ATRA WEBINAR

6L50-6L80-6L90 Updates and Product Issues

**Presented by:
Steve Garrett
ATRA Presenter**

6L50 - UPDATE

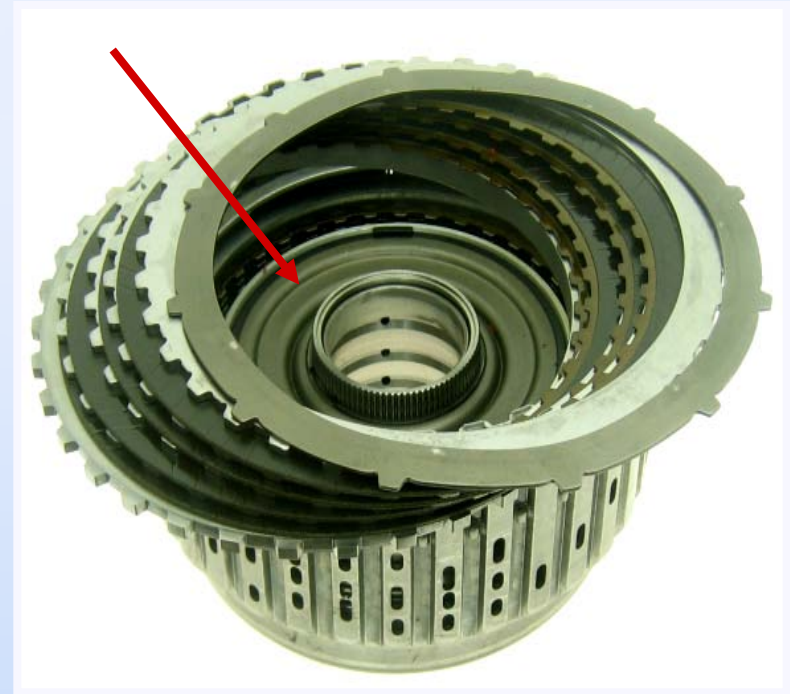
Delayed Engagement, Reverse Drain Down N-R – P-R Delay

3-5-Reverse Clutch Piston Capacity Reduction - SOP 2008 model year. Oil capacity was reduced by 20% for the 1-2-3-4/3-5-R clutches. This update limits the volume of oil required to stroke the piston. TCM Calibration was also changed due to this reduction of oil.

New Part Numbers:

- 24234213 – Reverse Clutch Piston
- 24248576 – Seal Kit 1-2-3-4/3-5-R Drum (Car)
- 24248578 - Seal Kit 1-2-3-4/3-5-R Drum (Truck)

- 24238696 – 3-5-R Clutch Piston
- 24238700 – 1-2-3-4 Clutch Piston
- 24243898 – 1-2-3-4/3-4-R Drum

6L45/50 AWD Applications

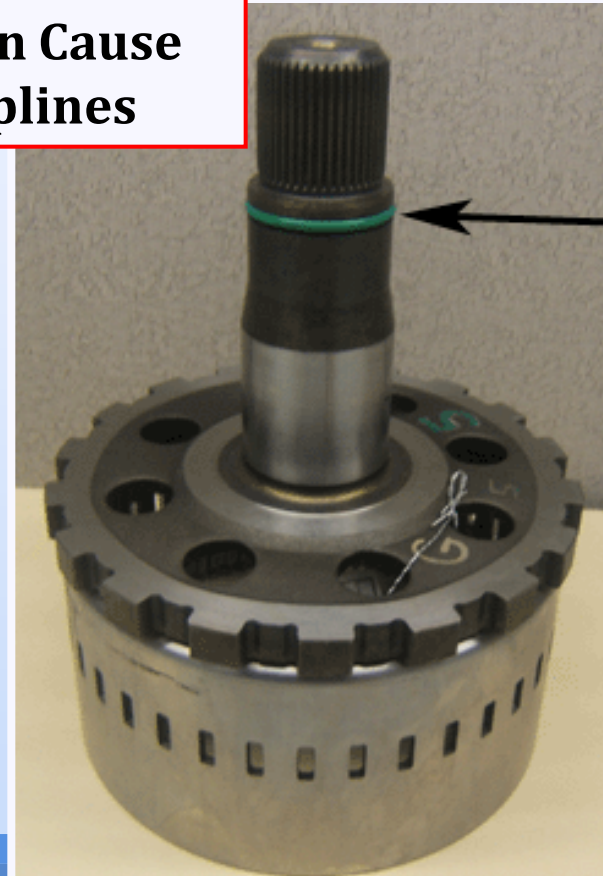
Grinding Noise, No FWD, No REV

The splines of the transmission output shaft or transfer case input shaft may be worn (rusted) or the shaft may have broke. The splines of the transmission output shaft have been updated with a groove for a O-Ring to help maintain the grease located between the transfer case input shaft and the transmission output shaft. Updated shafts require that “both the output shaft and input shaft be replaced as a set”.

Note:
If the splines of the
output shaft look ok,
use 2 o-rings GM#
24251228 along with
high temperature wheel
bearing grease during
assembly.

6L45/50 AWD Applications

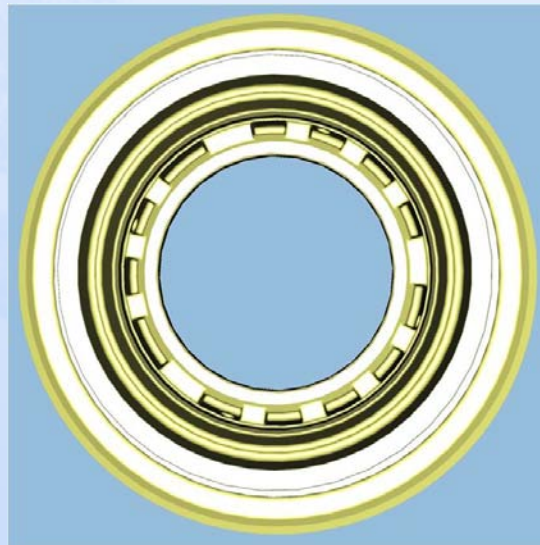
There were two other updates also made to the transmission output shaft. The hardening process was extended into the fillet radius (where output shaft usually breaks) and the design of the fillet changed to reduce the stress on that area of the shaft.

Updated Part #s

(MYB-6L50) - 24251229

(MYA-6L45) - 96043341

6L80 - UPDATE

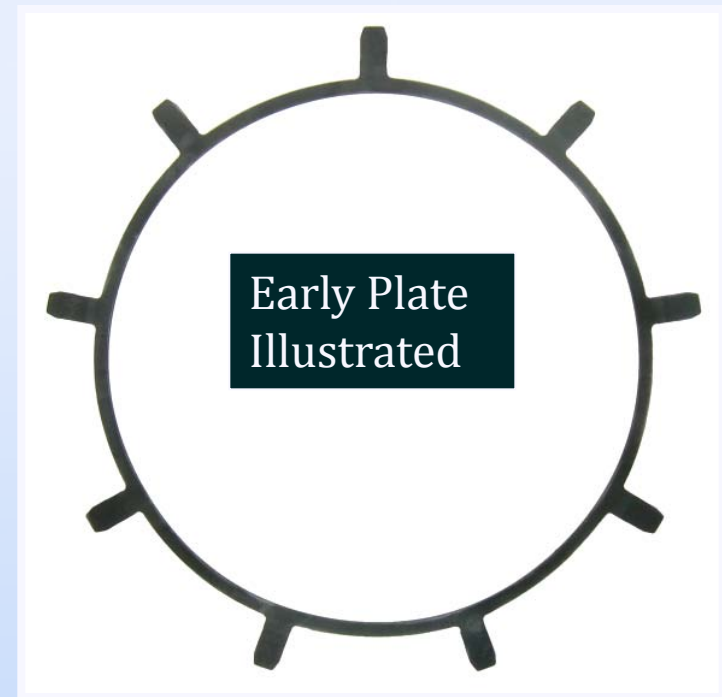
No Forward Movement

1-2-3-4/3-5-R Clutch Housing was updated mid 2007 to address a NO FORWARD condition. The root cause is the snap ring popping out of the housing. The housing has been updated to prevent this. Additionally the 3-5-R waved plate was updated from 12 to 18 teeth and the 1-2-3-4 wave plate was updated from 9 to 18 teeth.

- 24239828 – 3-5-R 18 tooth wave plate
- 24239615 – 1-2-3-4 18 tooth wave plate
- 24240194
- 24240201 – Selective Snap Rings
- 24241232 – Clutch housing Kit
(Includes Housing and Snap Rings)

1-2-3-4/3-5-R Clutch Housing

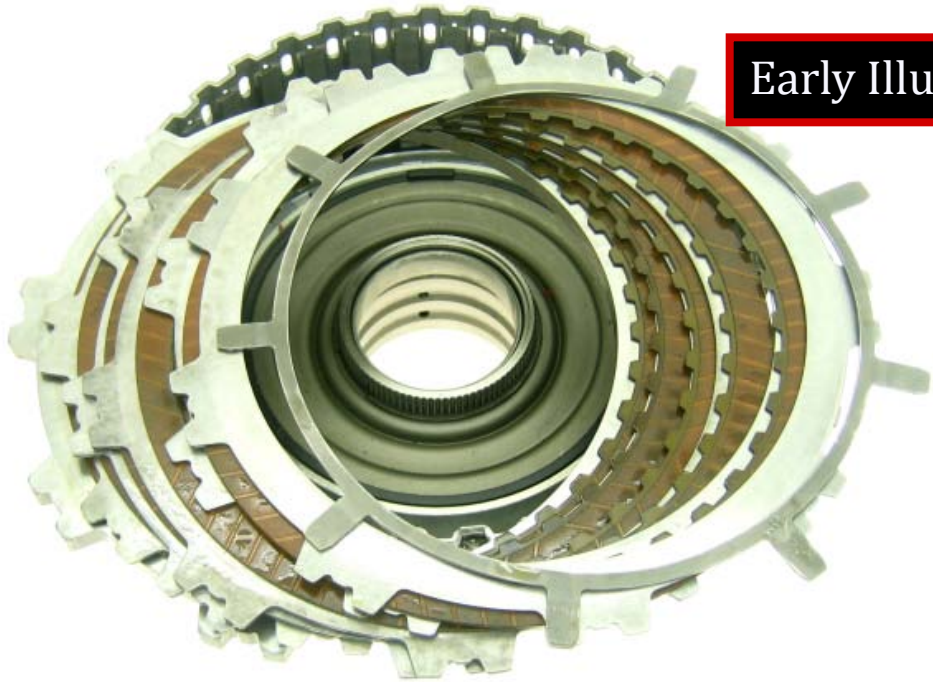
No Forward Movement

6L80 - UPDATE

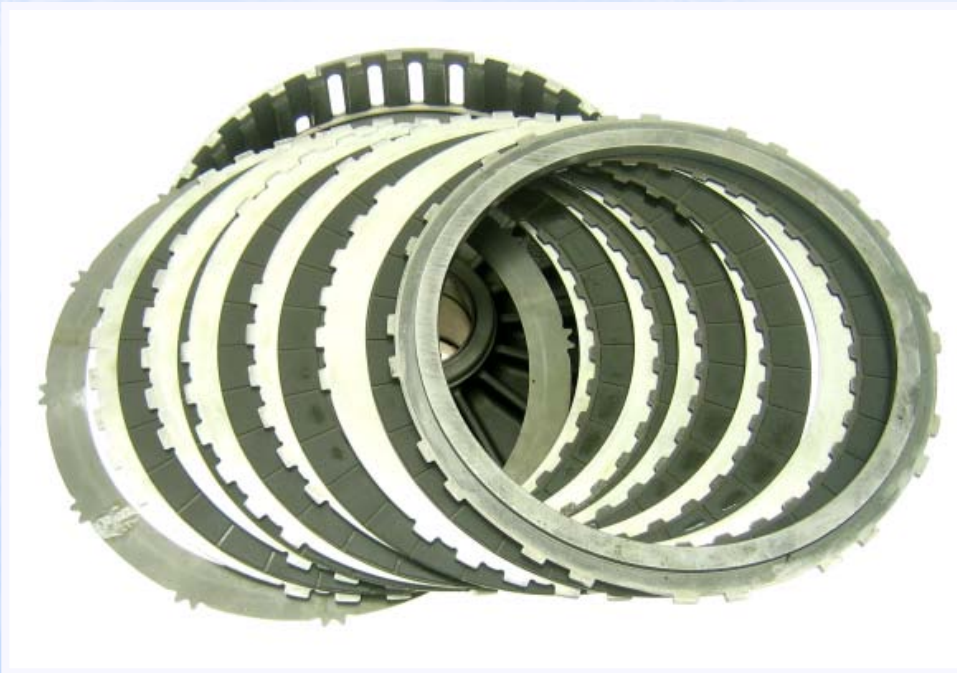
Clutch Shudder Condition

Low/Reverse Clutch Plates – Friction update was done to improve the Low/Reverse clutch apply (Shudder Complaint). Along with the frictions, a calibration update is needed when back servicing units

- 24235460 – Clutch Plate

DTC P1875

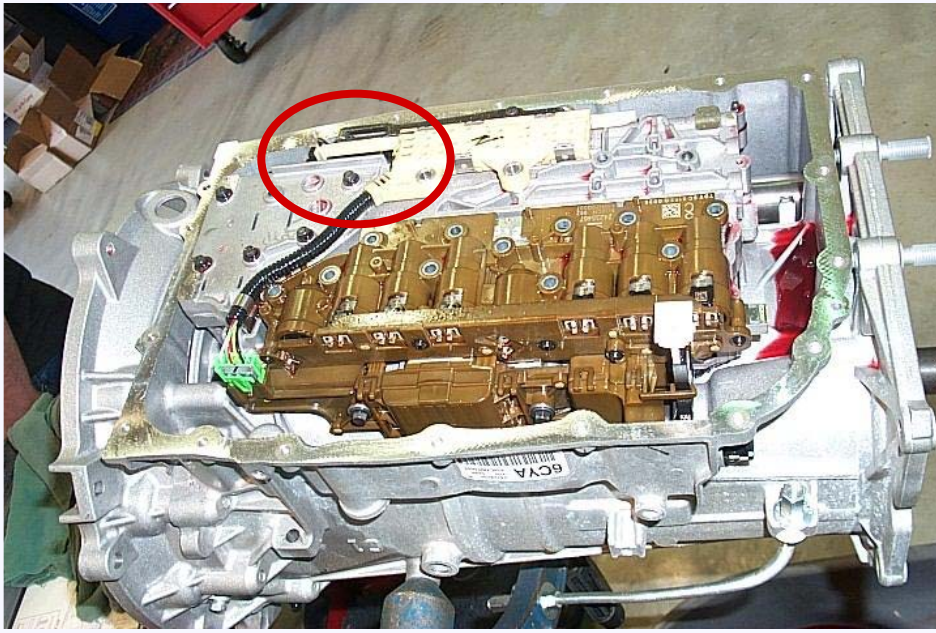
IMS Out of Range – IMS mid 2007, interim 2007 update. Oxidation was forming on the contacts leading to contact resistance. The updated IMS added additional nickel plating to the contacts and changed the lead frame to stainless steel to reduce the contact resistance.

- 24246427- IMS

Unigear update

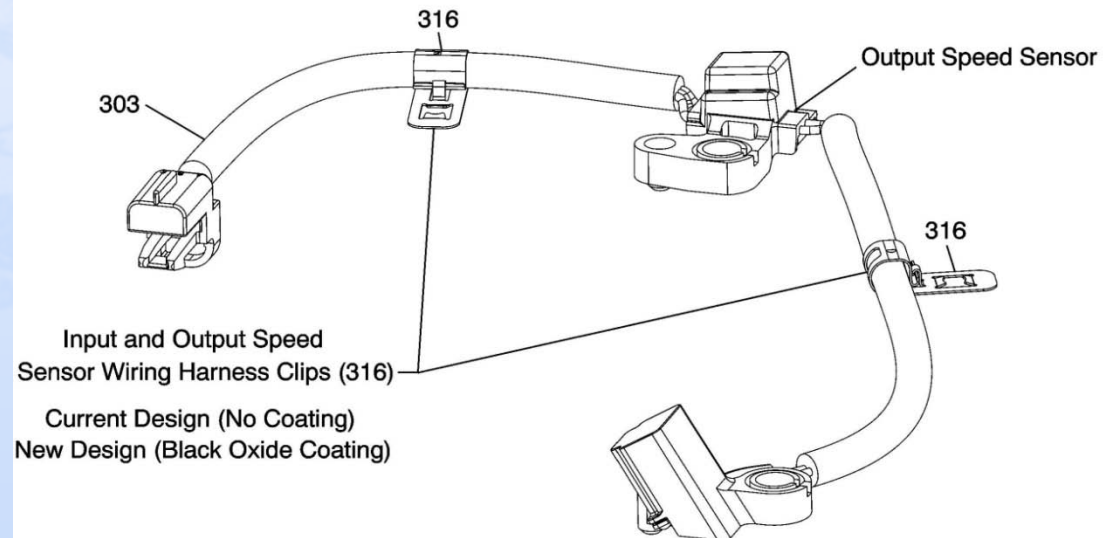
An update to the 6L80 and 6L90 (RPO MYC, MYD) transmission output ring gear and output shafts began to enter production starting with the March 2012 applications. All 6L80/6L90 transmissions will utilize the new design by the end of 2012. Known as a “UNIGEAR” design, the updated parts will incorporate the output ring gear and the output shaft into one assembly. The update was incorporated as a cost reduction measure and had nothing to do with durability. The new design will backservice the previous design applications as long as the speed sensor is replaced with it. The updated speed sensor is a different height because of the design of the unigear.

NOTE: If the previous design sensor is used with the Unigear design assembly damage to the sensor WILL occur and DTCs' will result as a result of the sensor damage. If the new design sensor is used with the previous design planetary/output shaft components Speed Sensor DTC's will result, as the air gap will be too wide.

24265536 Updated Unigear design compatible speed sensor 6L80/6L90

Spacer Plate and Valve Body Spring Updates

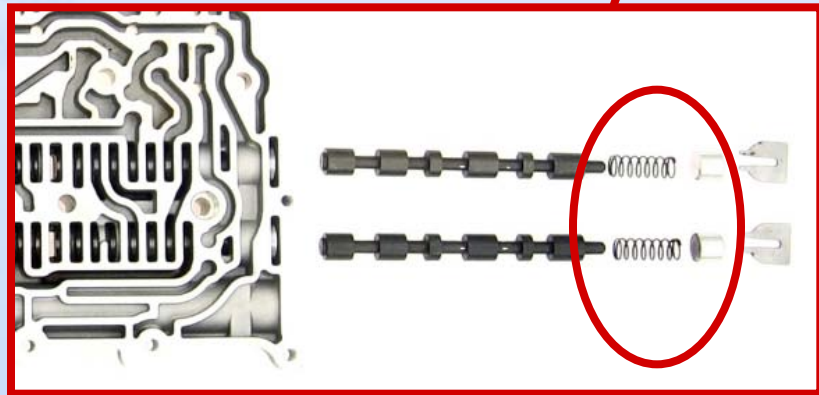
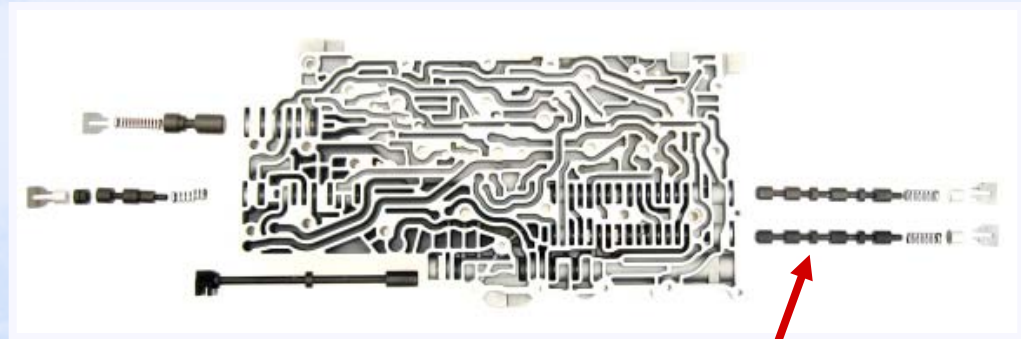
There have been 2 changes in the spacer plates used for the 6L80 starting in mid 2007 as a 2007 interim change adding an exhaust and a parallel path for a lube circuit bleed. In Mid 2008, interim 2008 change has also occurred to address a P0751 code. The spring load on the clutch select valves was lowered to allow the valves to move at a lower pressure reducing tendency of the P0751 code to set. These springs are not available individually.

- 24245720 – Spacer Plate
- 24250384 – Lower Valve Body with spring updates

6L80-6L90 - UPDATE

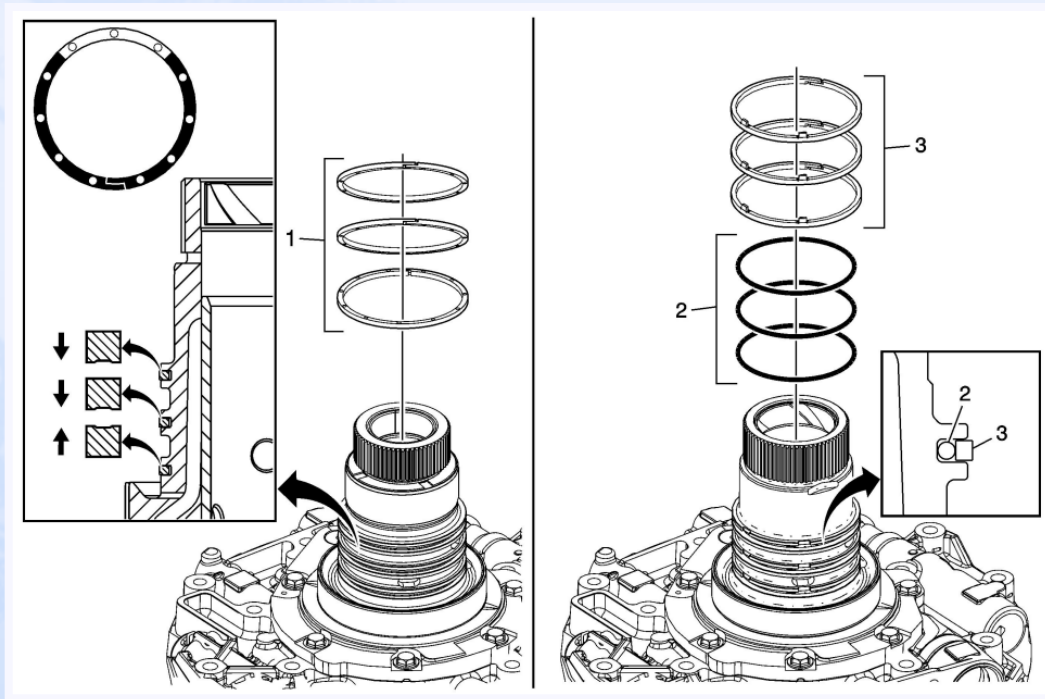
1-2-3-4 / 3-5-R Clutch Pump Cover Seal Update P0776 Slip
Design Change for mid 2009, Interim 2009. Update includes the grooves and seals that are located on the back of the pump cover. Update address's 2-3 shift complaints. The depth of the groove is deeper to allow for a rubber o-ring under the seal.

24248559 – Seal Kit (New Design)

Clutch Select Valve #3

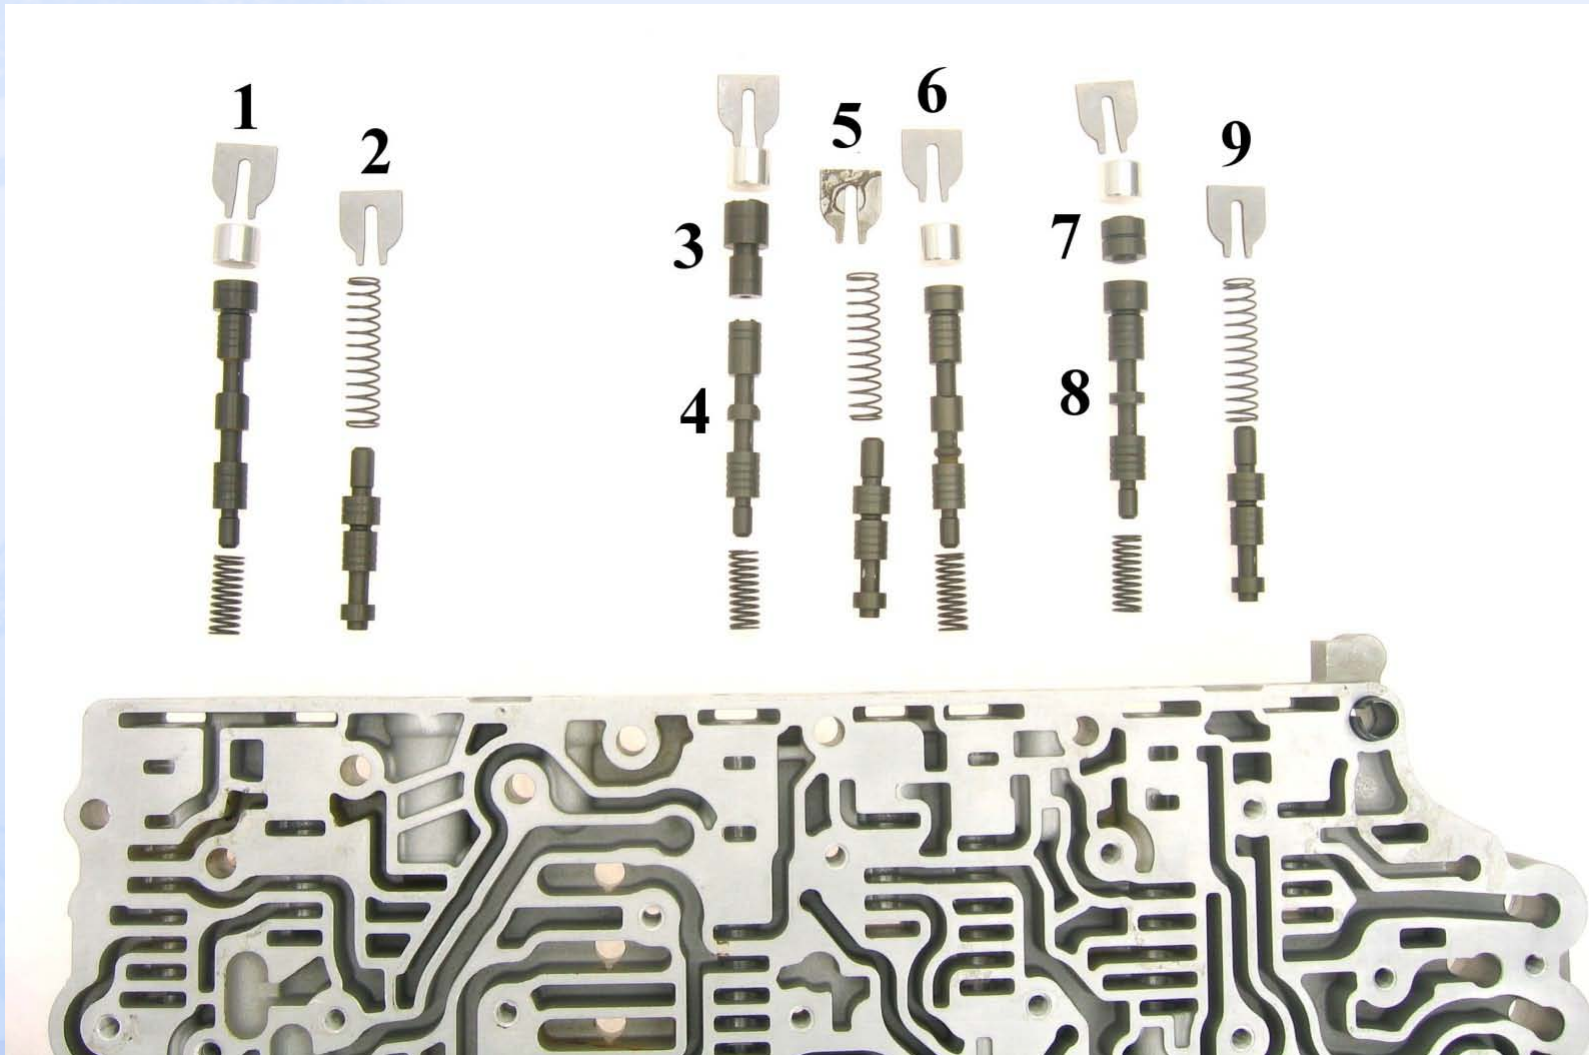
- **P0756 – Inspect the Clutch select valve #3 in the lower valve body for evidence of wear and sticking.**
- **P0776 – Inspect the 3-5-R clutch regulator valve in the upper valve body for evidence of wear and sticking. Inspect the 3-6 reverse drum for cracks, inspect the seals for leakage.**
- **P0796 – Inspect the CBR1/4-5-6 clutch regulator valve in the upper valve body for evidence of wear and sticking. Inspect the seals/circuit for leakage.**
- **P2714 – Inspect the 2-6 clutch regulator valve in the upper valve body for evidence of wear and sticking. Inspect the seals/circuit for leakage.**
- **P2723 – Inspect the 1-2-3-4 clutch regulator valve in the upper valve body for evidence of wear and sticking. Inspect the seals/circuit for leakage.**
